INTERIM RECORD OF DECISION  
SAN GABRIEL VALLEY SUPERFUND SITE  
PUENTE VALLEY OPERABLE UNIT  
CITY OF INDUSTRY, CALIFORNIA

September 1998

United States Environmental Protection Agency  
Region IX - San Francisco, California

**Figure 3**  
**1997 Intermediate VOC Contamination,**  
**Puente Valley Operable Unit**

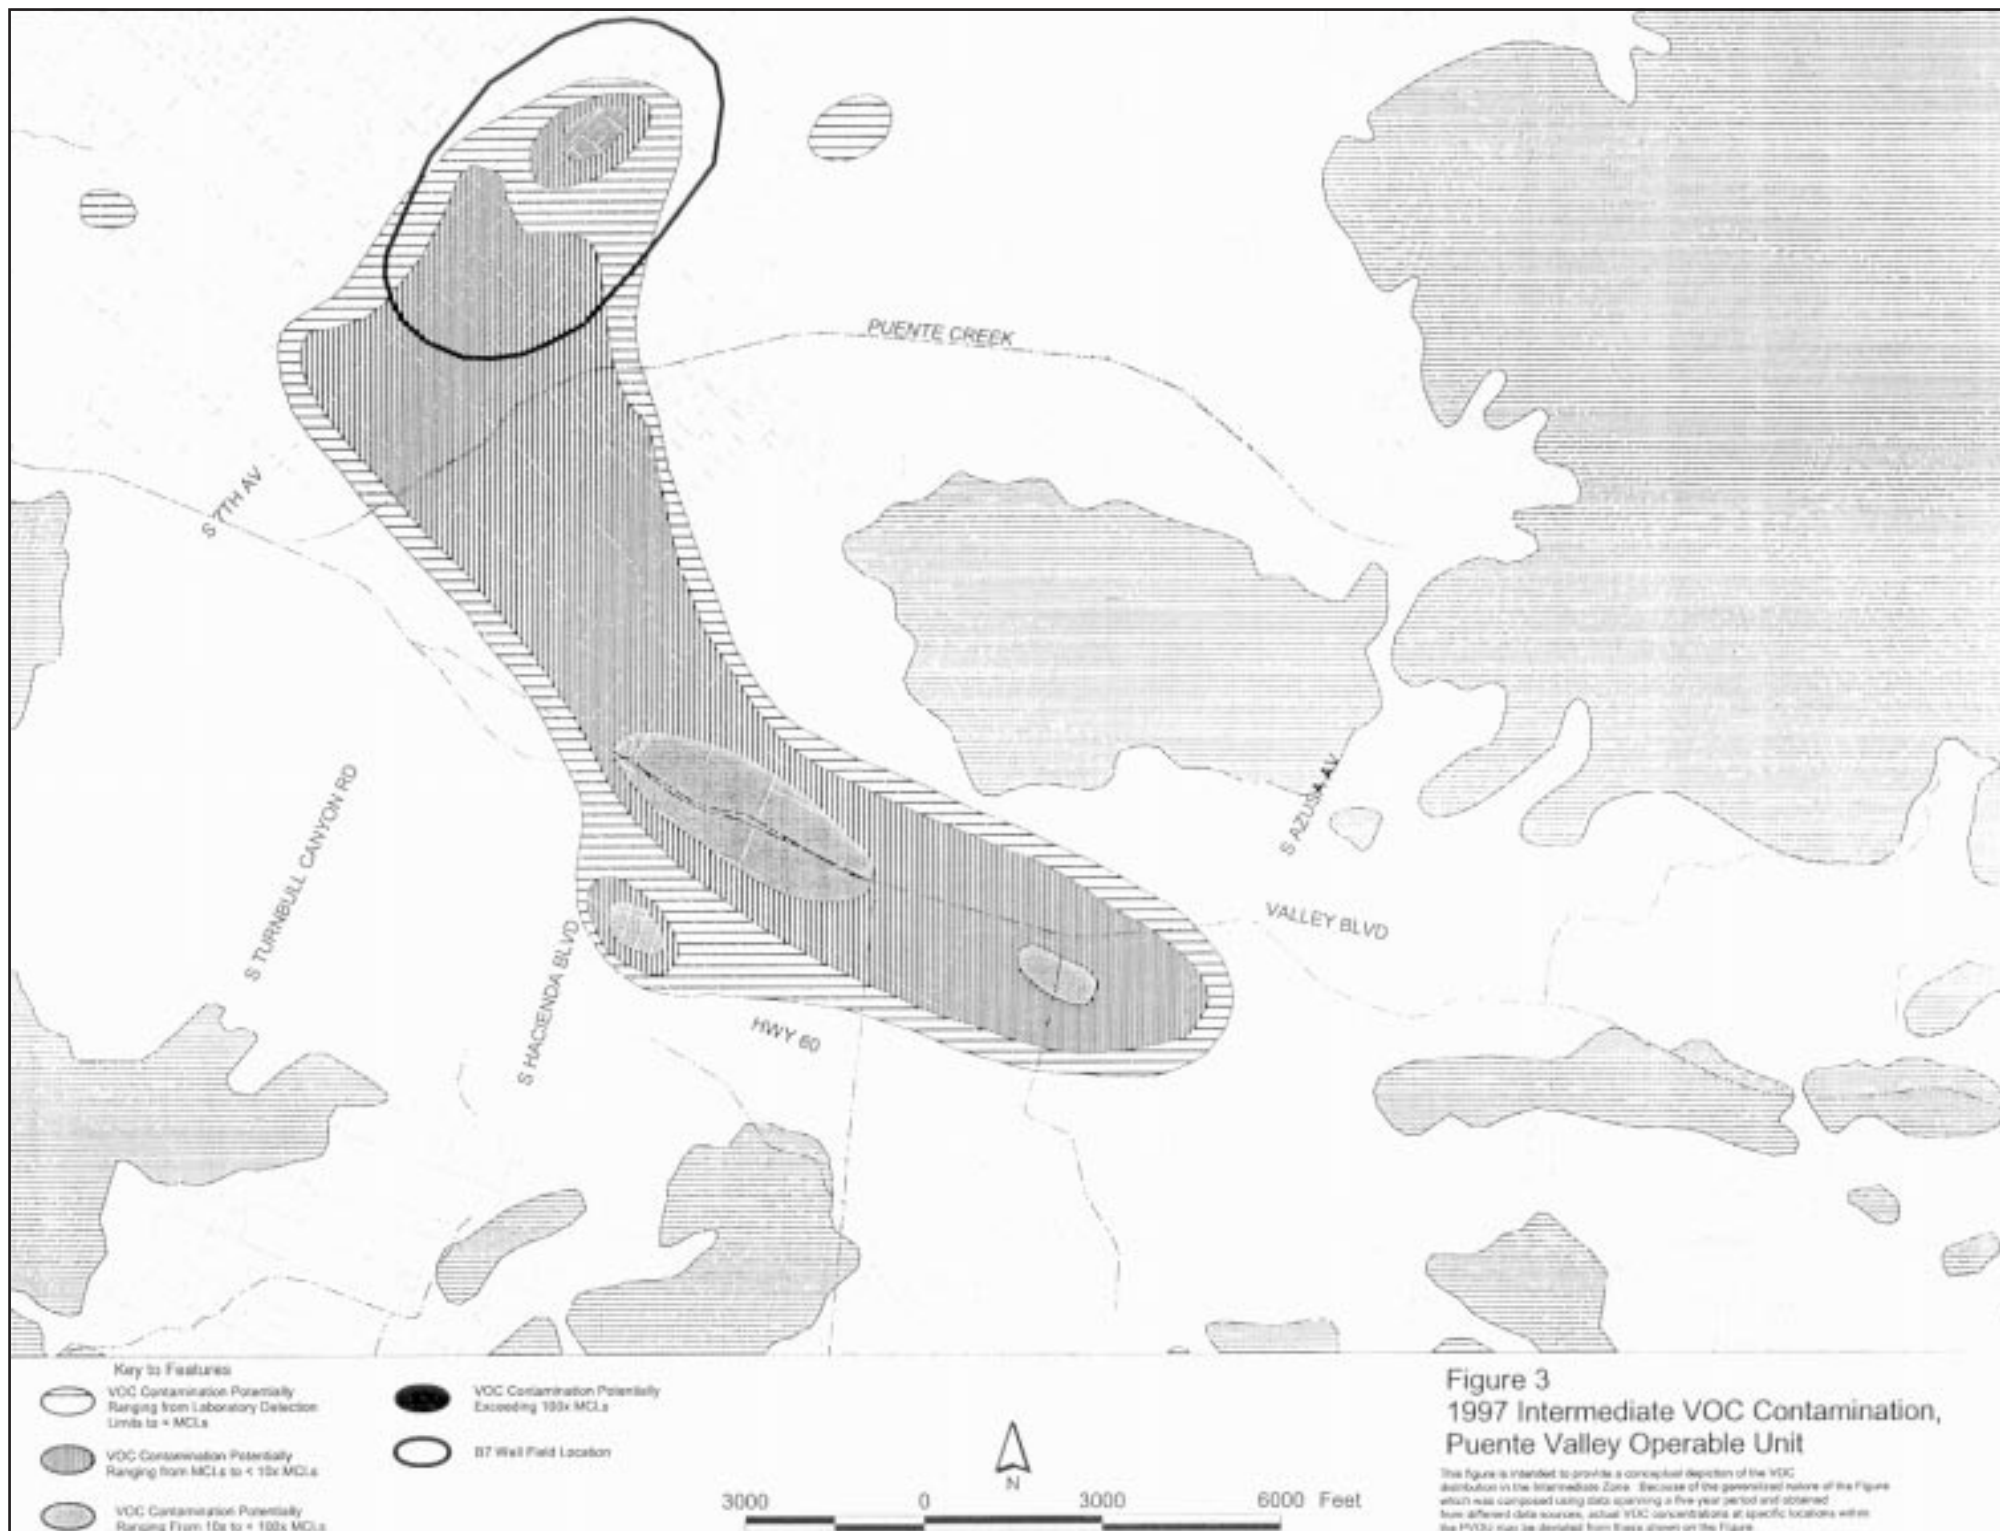
**PVSC Comment 3:** *At the end of "Site Description" it is stated that "Figures 2 and 3 show 1996 VOC concentrations in the shallow and intermediate zones." In meetings with the PVSC, EPA has agreed that such depictions represent substantial simplifications of the actual magnitude and extent of VOC distribution. The figure referenced in this Proposed Plan, therefore, is misleading and inaccurate. EPA's revised plume maps which were presented in the January 28 public meeting and based in part on data collected by the PVSC in October and November 1997 are also misleading, as they were generated using some data that are 5 years old or older. Furthermore, the deep zone VOC maps rely heavily on inactive production wells where the VOCs are likely derived from shallow, and not "deep", contamination.*

This figure is intended to provide a conceptual depiction of the VOC distribution in the Intermediate Zone. Because of the generalized nature of the figure which was composed using data spanning a five year period and obtained from different data sources, actual VOC concentrations at specific locations within the PVU may be derived from those shown on the figure.

**EPA' Response:** Figures 2 and 3 in the ROD provide supplemental text explaining that they are simplified representations of the magnitude and extent of the VOC contamination in the PVOU.
